Wisconsin Department of Transportation

**Proposal #01: 1517-07-77, WISC 2016 229
USH 10 – USH 10/STH 441
County CB – Oneida Street
I-41 Interchange Bridges and
LLBDM Bridge B-70-61 Redeck
USH 10
Winnebago County**

This is Addendum No. 02, which provides for the following:

PROJECT NO: 1517-07-77	HWY: USH 10	COUNTY: WINNEBAGO	PLAN DETAILS	SHEET 33A	E
FILE NAME : M:\56537\1517-07-77\1\cbs\021202-p4.dgn			PLOT BY : grossemeyer		WISDOT/CADD SHEET 42
PLOT DATE : 6/29/2016			PLOT NAME :		
PLOT SCALE : 40:1

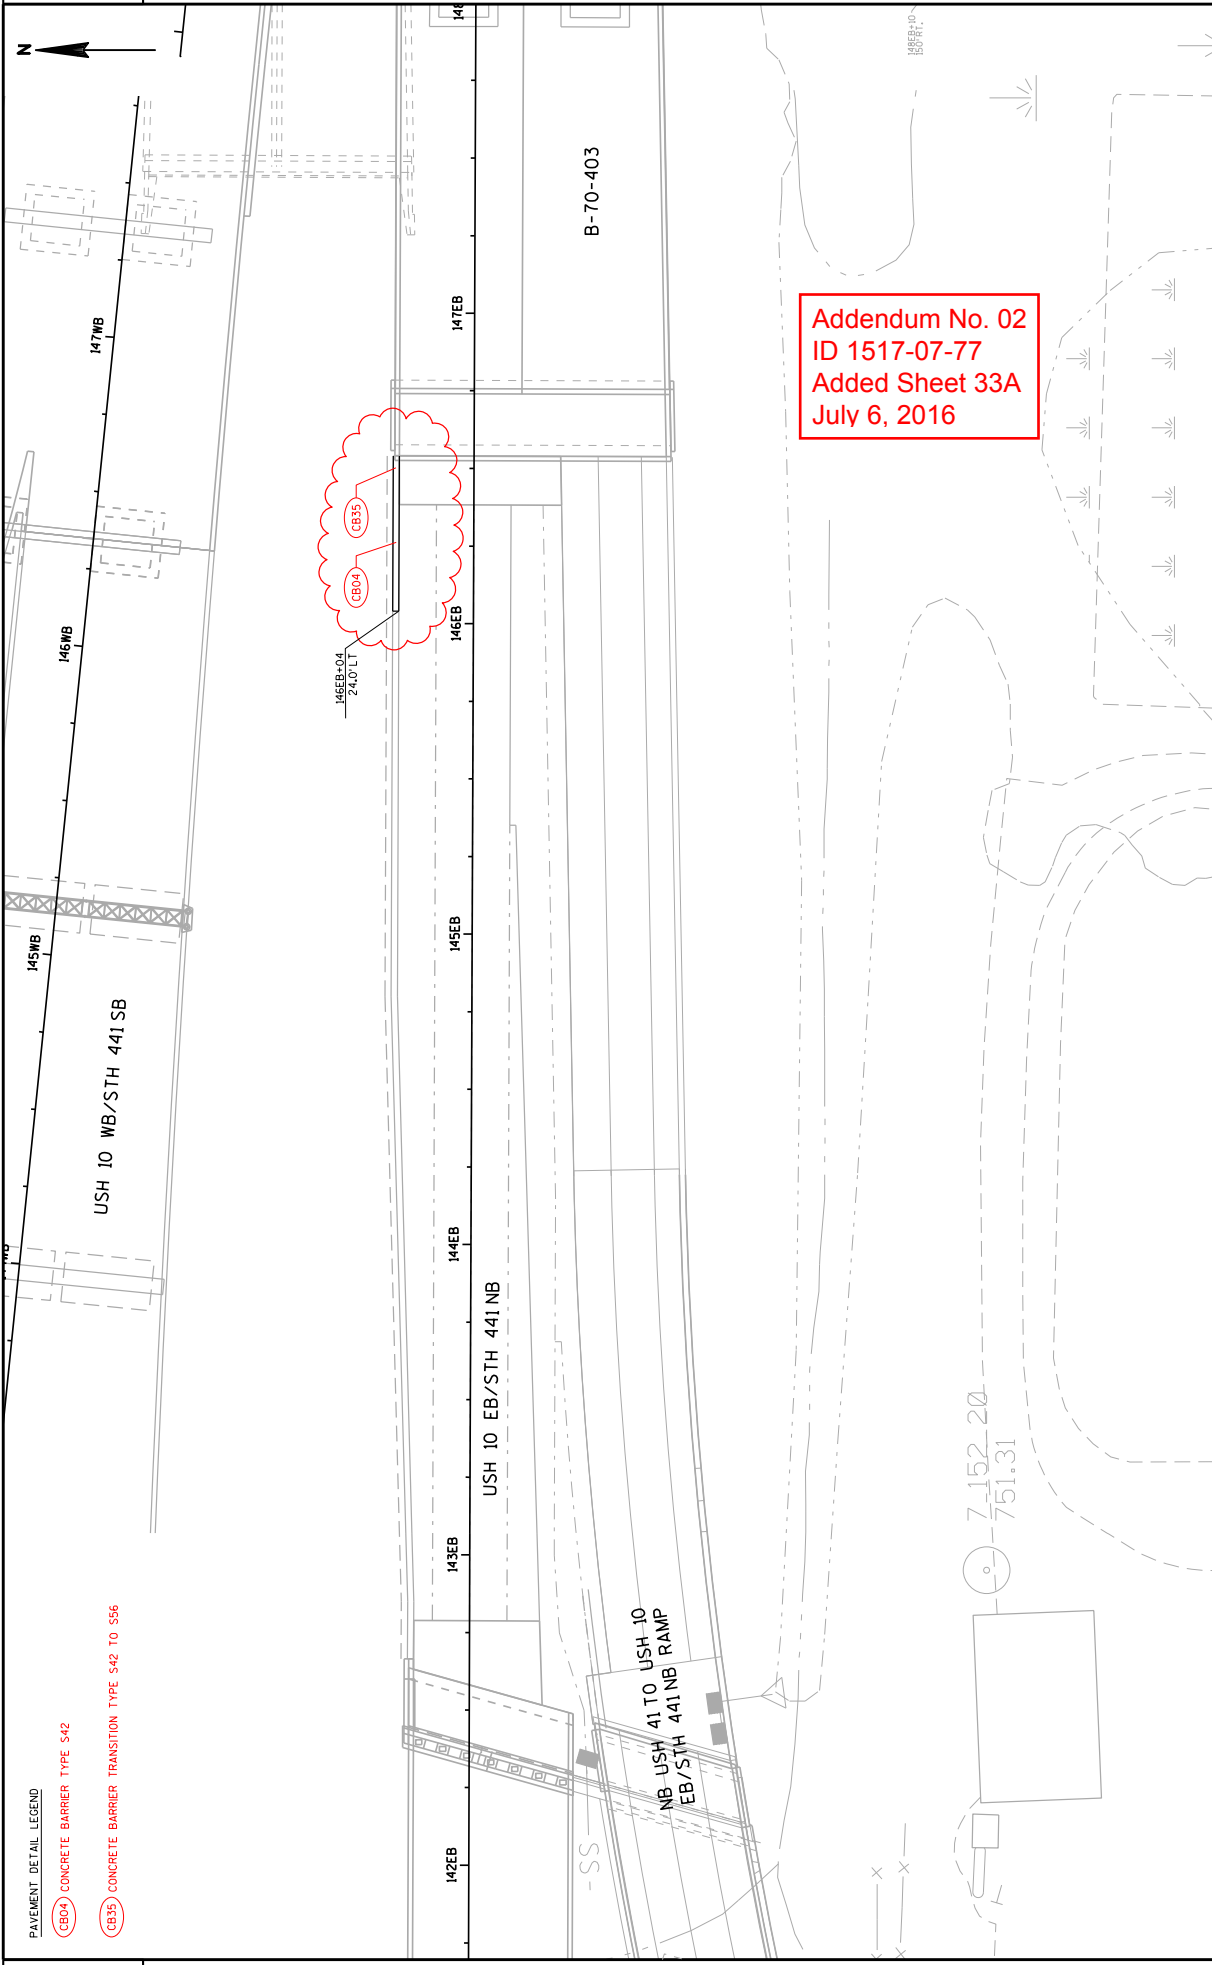
Added Plan Sheets	
Plan Sheet	Plan Sheet Title (brief description of why sheet was added)
33A	Plan Details (B-70-403 west abutment median barrier)

Addendum No. 02
 ID 1517-07-77
 Revised Sheet 73
 July 6, 2016

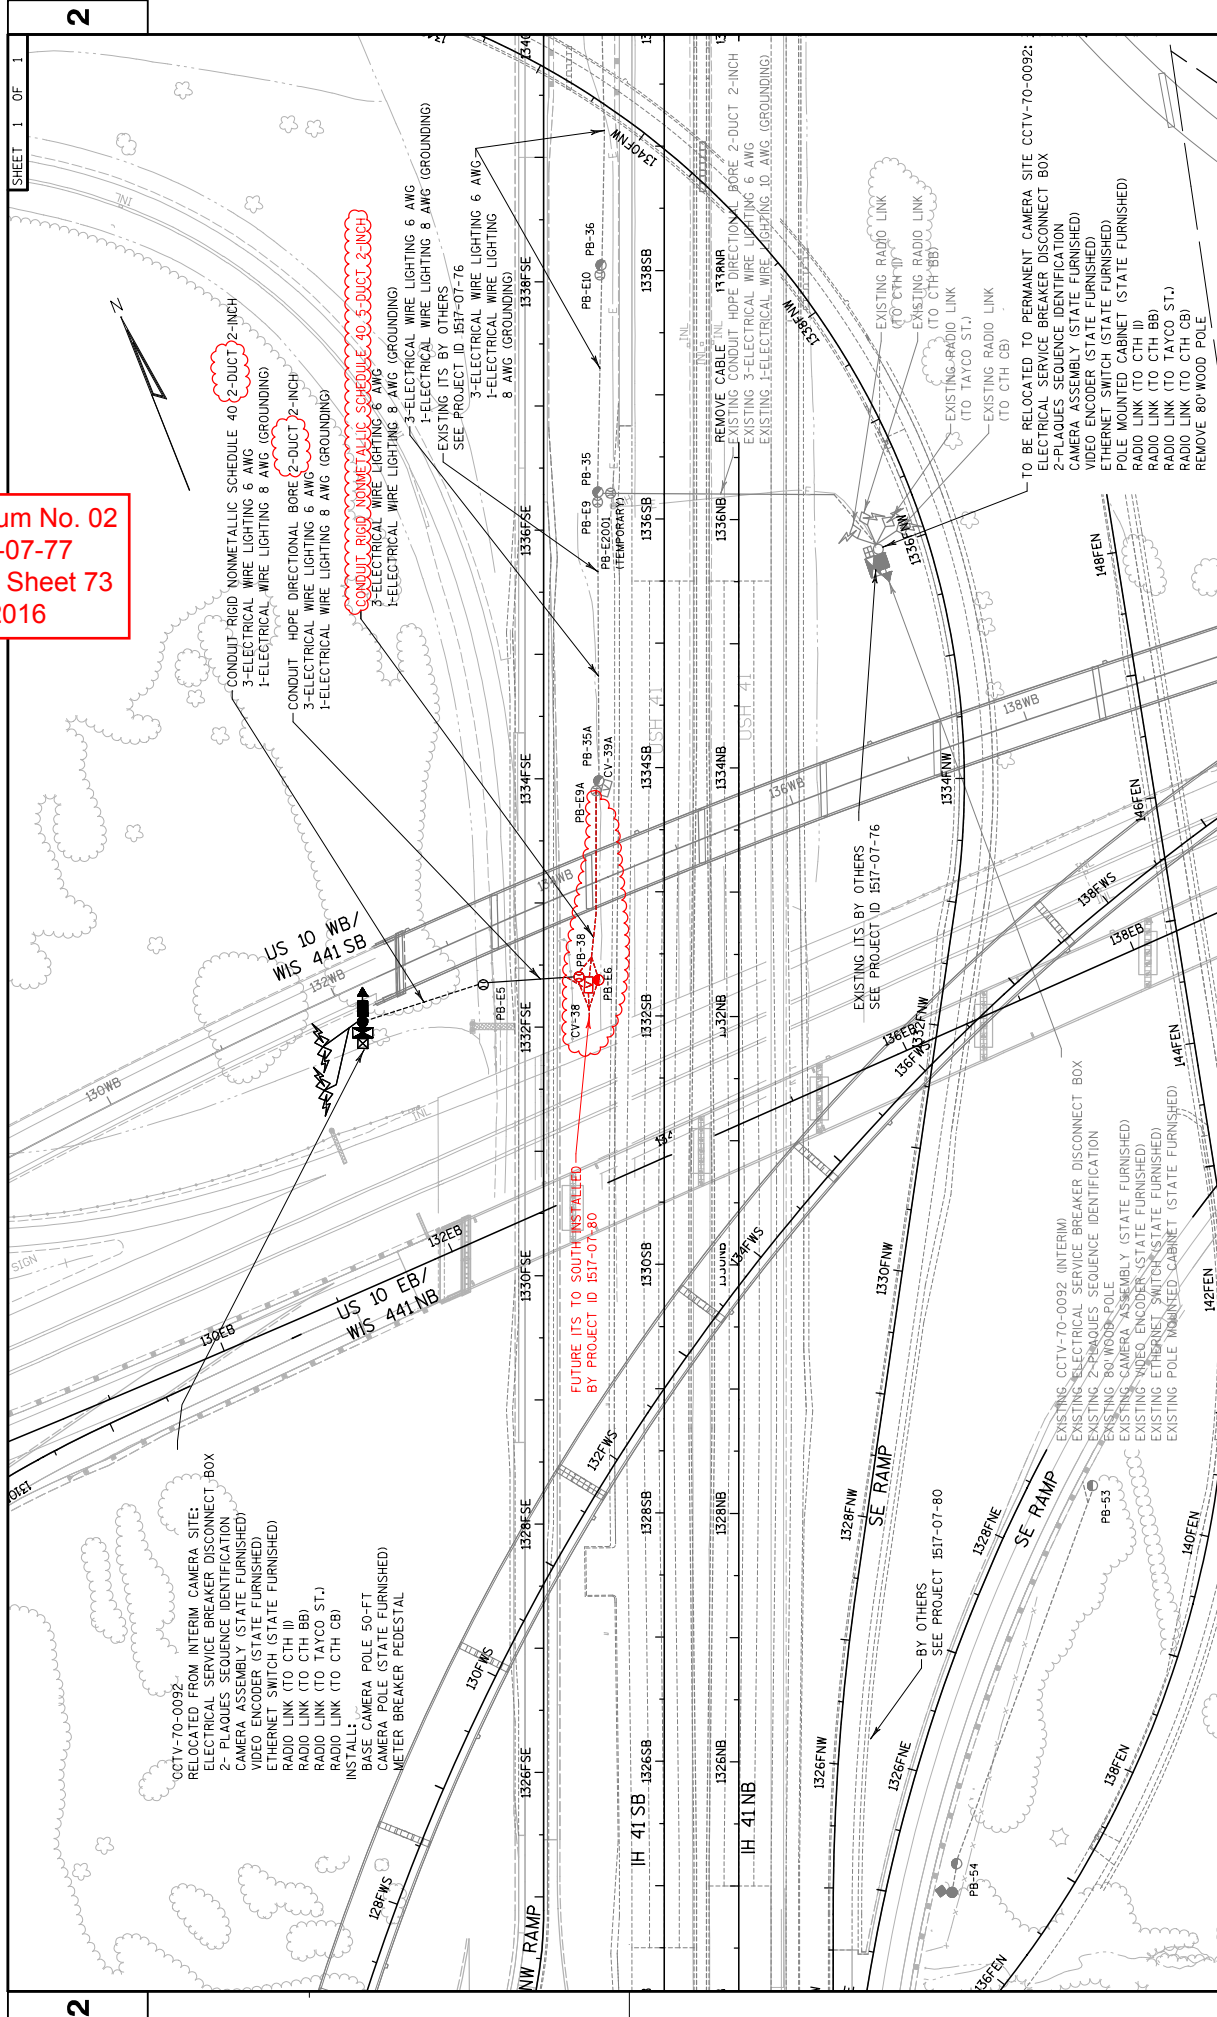
Revised Plan Sheets	
Plan Sheet	Plan Sheet Title (brief description of changes to sheet)
73	ITS plan (added conduit/vaults that are no longer part of 1517-07-76)
89	Lighting Plan (Added conduit and lighting base)
141	Miscellaneous Quantities (Earthwork changes)
143	Miscellaneous Quantities (Concrete Barrier addition changes)
145	Miscellaneous Quantities (Delineators and restoration changes)
148	Miscellaneous Quantities (Concrete Barrier left in place changes)
150	Miscellaneous Quantities (Lighting quantity changes)
151	Miscellaneous Quantities (Lighting quantity changes)
173	Miscellaneous Quantities (ITS quantity changes)

STATE OF WISCONSIN	
DEPARTMENT OF TRANSPORTATION	
STRUCTURE B-70-61	
DESIGN BY	PSK
CHECKED BY	NPP
GENERAL PLAN	
SPANS 7-11	
SHEET 2 OF 109	
309

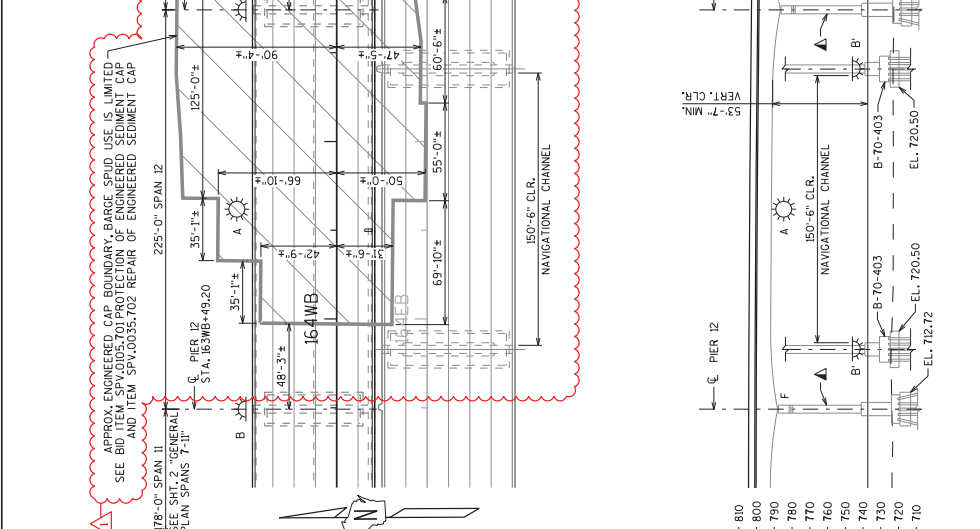
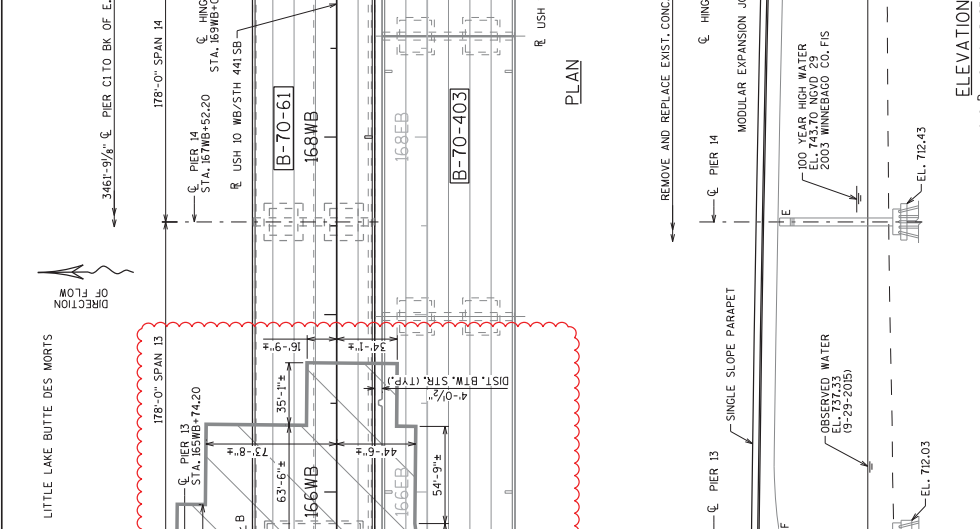
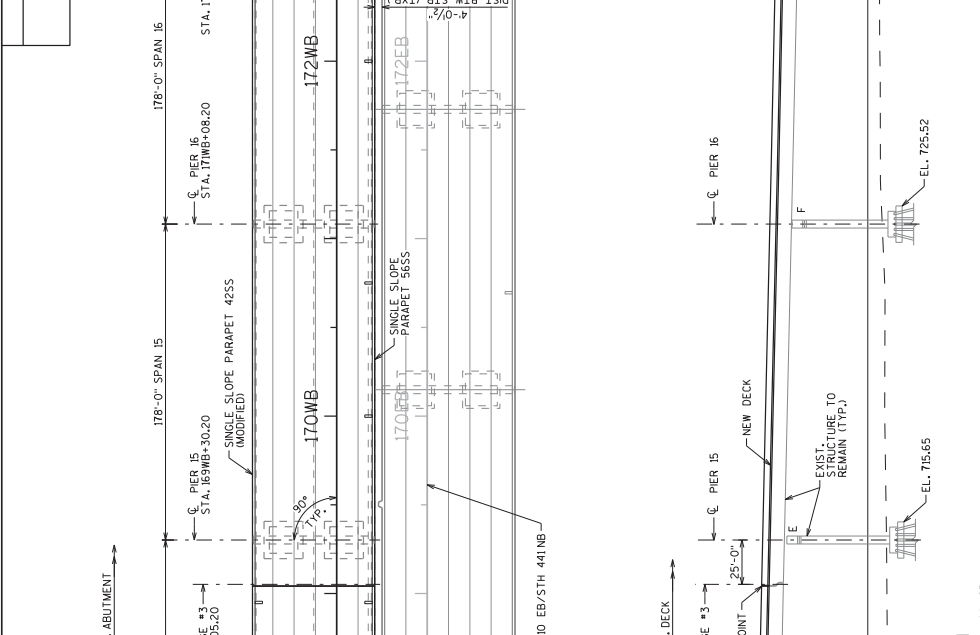
309	General Plan Spans 7-11 (Added sediment cap details)
310	General Plan Spans 12-16 (Added sediment cap details)
312	General Notes (Revised and added general notes)
313	Estimated Quantities (Revised qtys and added bid items)
419	General Notes and Quantities (Added bid item)
483	Parapet Electrical Work (Revised end of bridge conduit routing)
502	General Notes and Quantities (Updated Quantities, Added Bid Item)
514	Pier 4 Layout (Added Optional Construction Joint, Bearing Elevations)
515	Piers 5, 7, 8 Layout (Added Optional Construction Joint)
516	Pier 6 Layout (Added Optional Construction Joint)
517	Pier 9 Layout (Added Optional Construction Joint)
525	Piers 5-8 Shaft Reinforcing (Updated Shaft Bars)
536	Bearing Design Data (Updated Bearing Height)
571	Parapet Electrical (Revised end of bridge conduit routing)
585	General Notes and Quantities (Added bid item)
646	Parapet 32SS Electrical Work
668-669	Earthwork (FEN & FNW Ramps)

NO.	DATE	REVISION	PROTECTION OF SEDIMENT CAP	PSK
1	7-1-16

STATE OF WISCONSIN
 DEPARTMENT OF TRANSPORTATION
 STRUCTURE B-70-405
 PARAPET ELECTRICAL
 SHEET 74 OF 85
 571

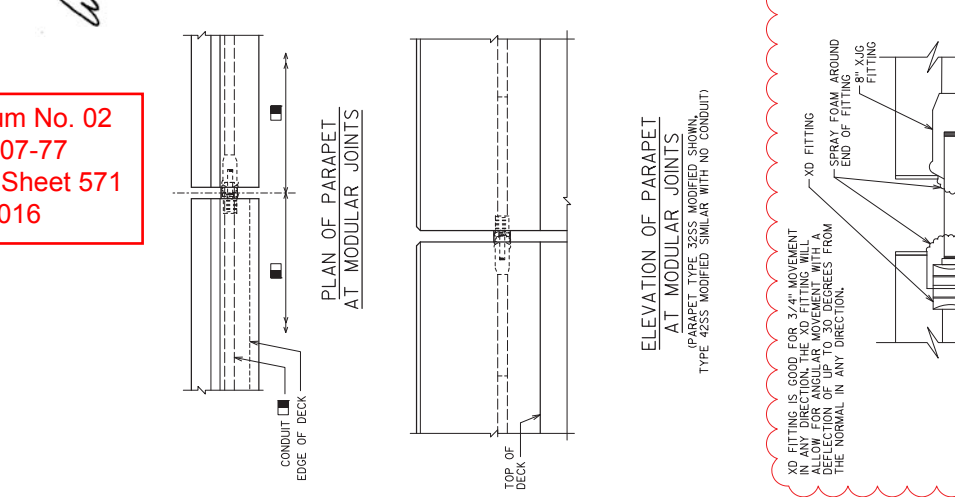
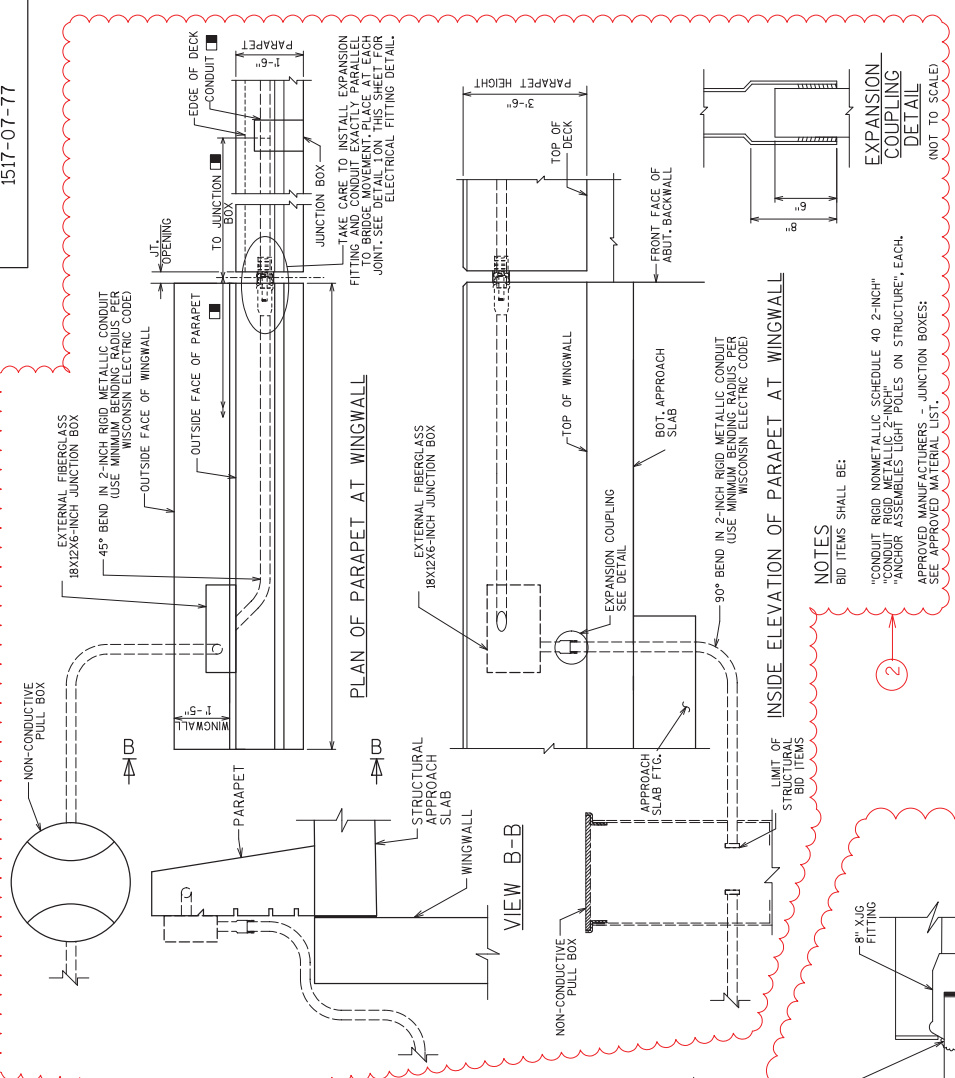
NO.	DATE	REVISION	BY
1	5/7/16	REVISED FITTING DETAIL	JDL
2	7/1/16	CONDUIT ROUTING AT BRIDGE END	MJA
